AGENDA
VILLAGE BOARD MEETING
Tuesday, April 13, 2021 at 7:30 p.m.
Jackson Village Hall
N168 W20733 Main Street
Jackson, WI 53037

14. Village Municipal Complex – Update – Cedar Corp

JACKSON MUNICIPAL COMPLEX SWITCH GEAR PROVISIONS - STORAGE ROOM 2D19

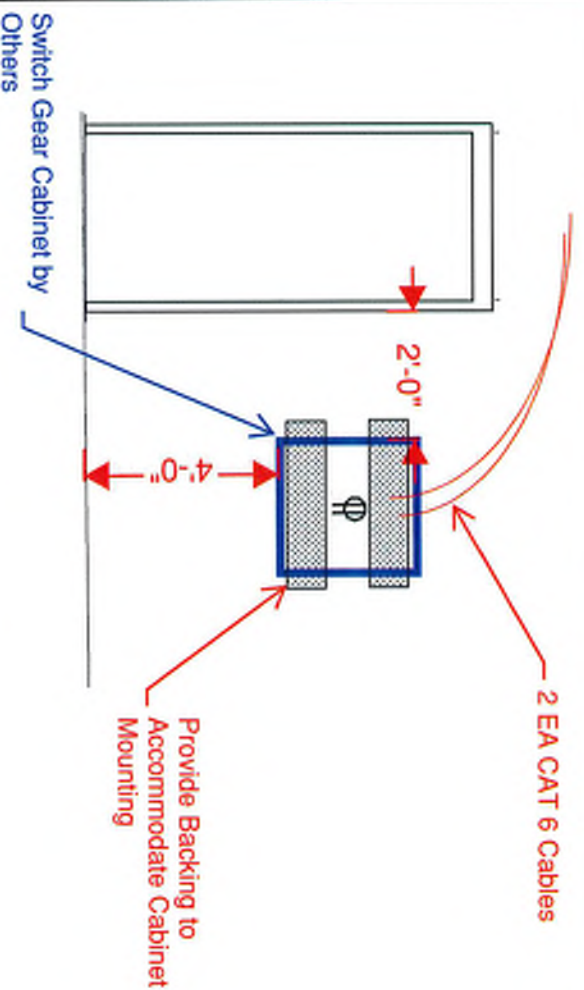
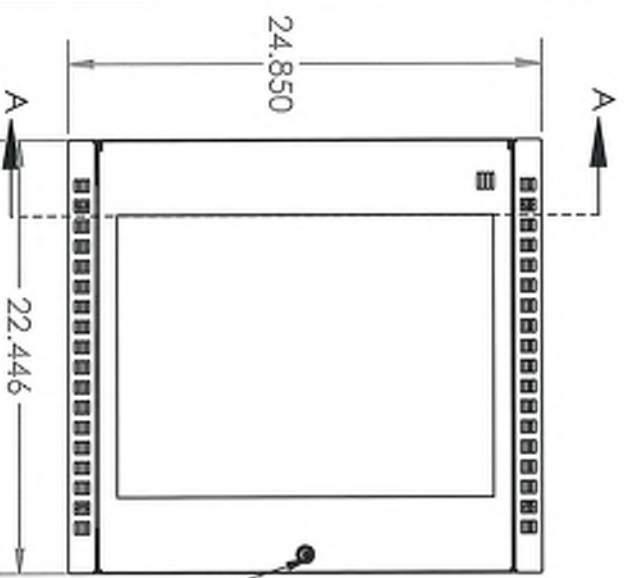
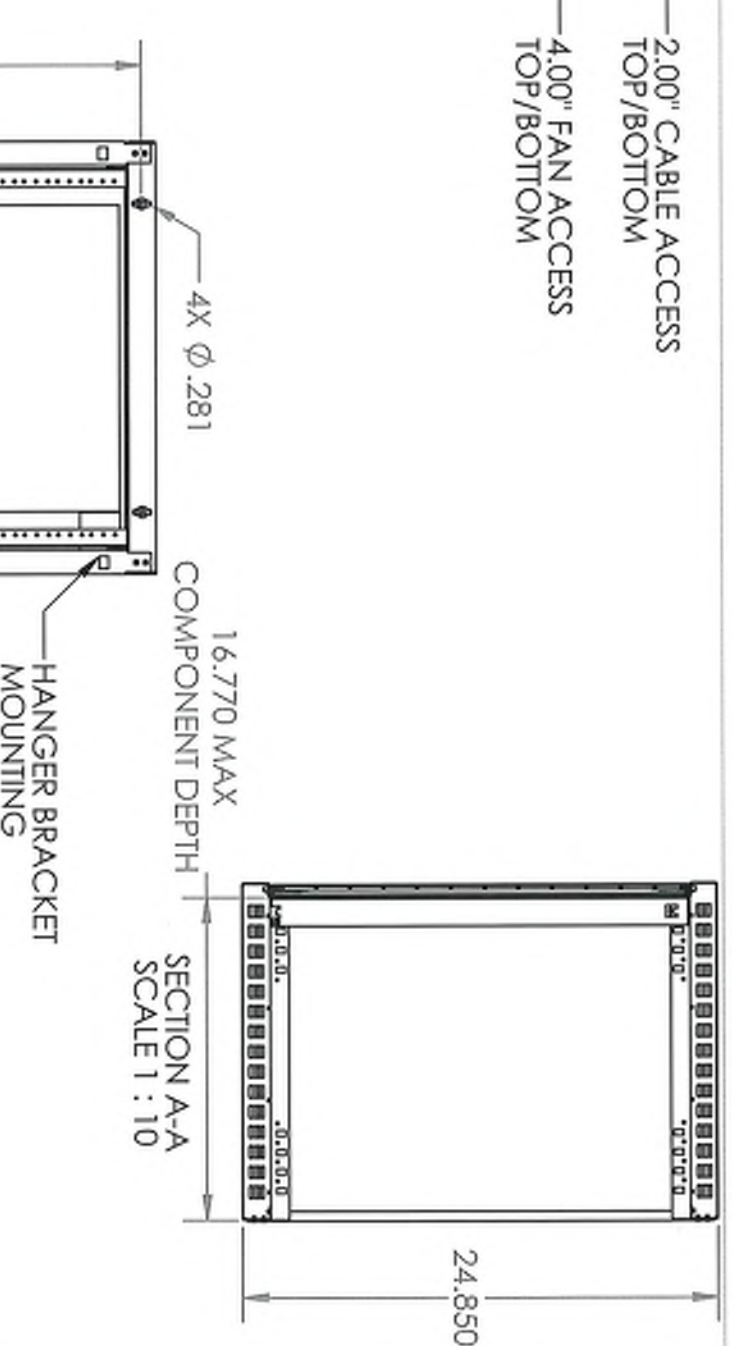
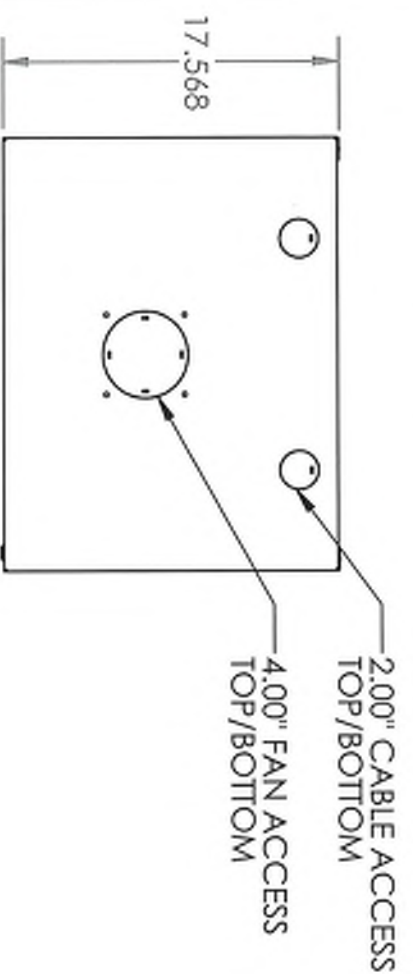
As discussed previously, attached please find revised Drawing sheets E202D, E601, E604, & E605 associated with electrical revisions located within Rooms 2D19, 2D06, 2D13-18 & 1D11. At your earliest convenience, please provide a detailed cost proposal associated with this proposed work.

- **Storage Room 2D19: Contractor provide additional backing and relocate electrical receptacle and 2 EA CAT 6 cables from IT Room to Switch Gear Location to accommodate proposed switch gear.**

1. Switch Gear Cabinet mounting location: 4'-0" AFF (to bottom of cabinet), 2'-0" offset from door frame.
2. Install 2 EACH CAT 6 cables to within proposed cabinet location.
3. Relocate electrical receptacle to within proposed cabinet location.
4. Install backing within stud cavities to accommodate cabinet mounting.

LIFE SAFETY
PLAN - SECOND
FLOOR

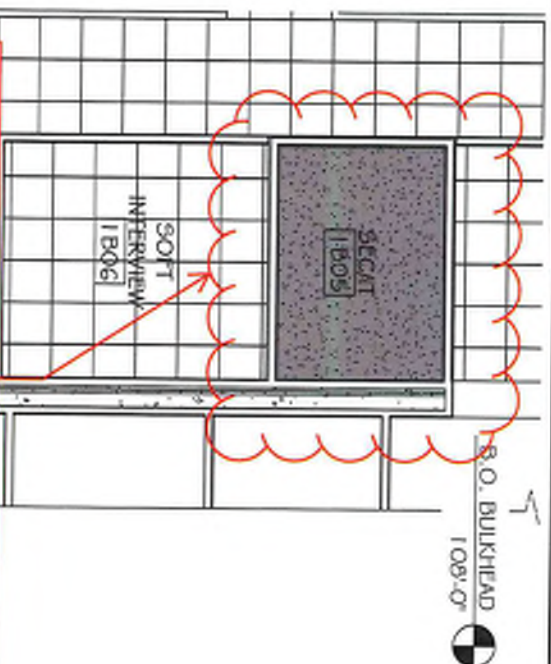
1. DELETE 2 HR FIRE RATED CEILING - UL DESIGN NO. G535 FROM ROOMS: 2D13, 14, 16, 17 & 18.
2. EXTEND SINGLE LAYER OF GYPSUM BOARD ON EACH SIDE OF DORM ROOM WALLS TO ROOF DECK ON ALL NON-PRECAST WALLS.
3. PROVIDE 5/8" SOUND BREAK GYPSUM BOARD AT INTERIOR SIDE OF DORM ROOM WALLS IN LIEU OF 5/8" TYPE "X" (WALL ASSEMBLY SHALL HAVE AN STC RATING OF 54)
4. INSTALL ACOUSTIC CEILING WITHIN EACH DORM ROOM AT 9' AFF.
5. REMOVE SOFFITS PROPOSED ABOVE CABINET SYSTEMS PER SHEET A221 DETAIL 17

1 ENLARGED FIRST FLOOR HVAC PLAN 'D'
SCALE: NTS

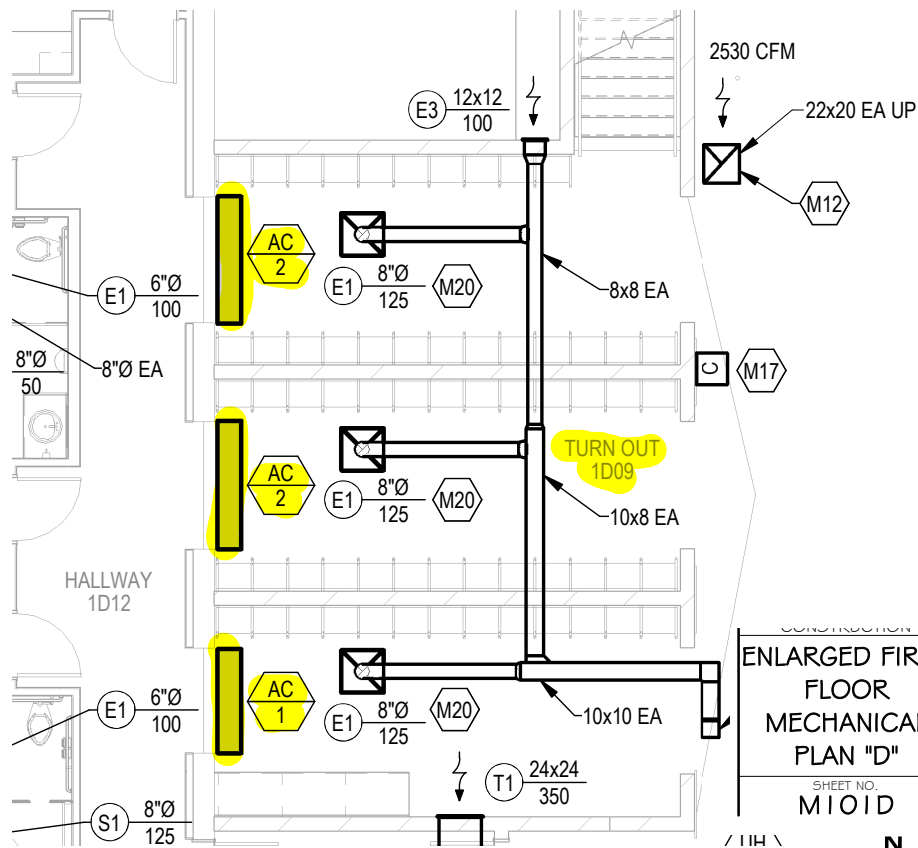
- Change Order #6 – Municipal Complex Building
 - Work Change Directive #19 Main Lobby Floor Outlets – Municipal Complex Building
 - Work Change Directive #20 Air Curtains – Municipal Complex Building

18 SECTION @ LOBBY DISPLAY CABINET
 A221 1/2" = 1'-0"

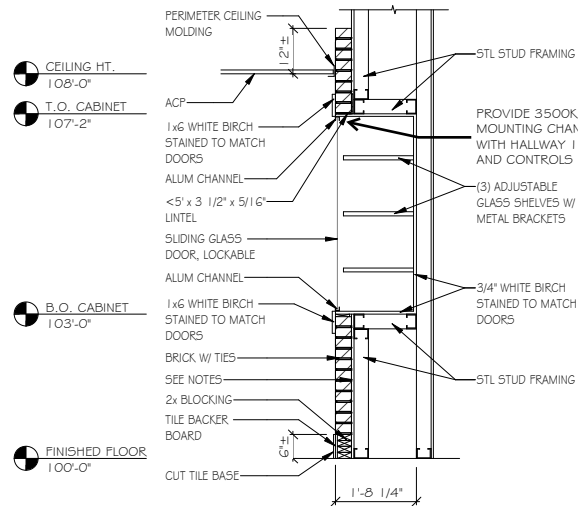
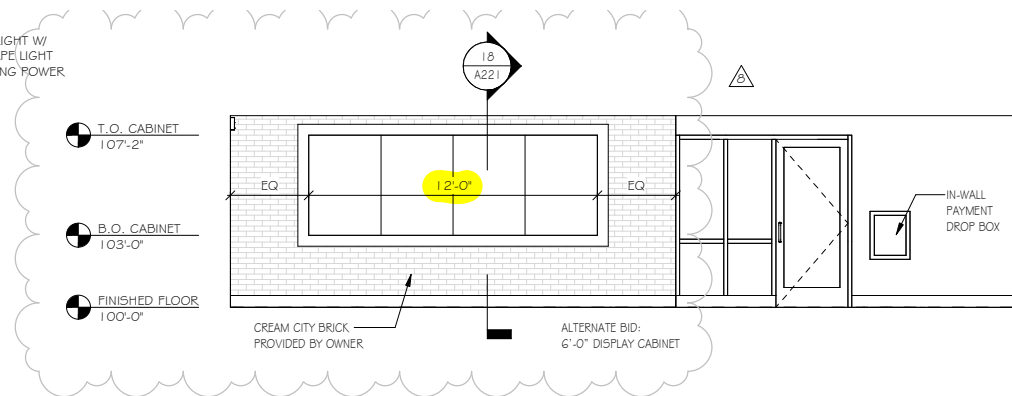
- Work Change Directive #21 Display Cabinet – Municipal Complex Building
 - Change Order #2 – 2020 Road and Utility Project – Wondra Construction
11. Plan Commission
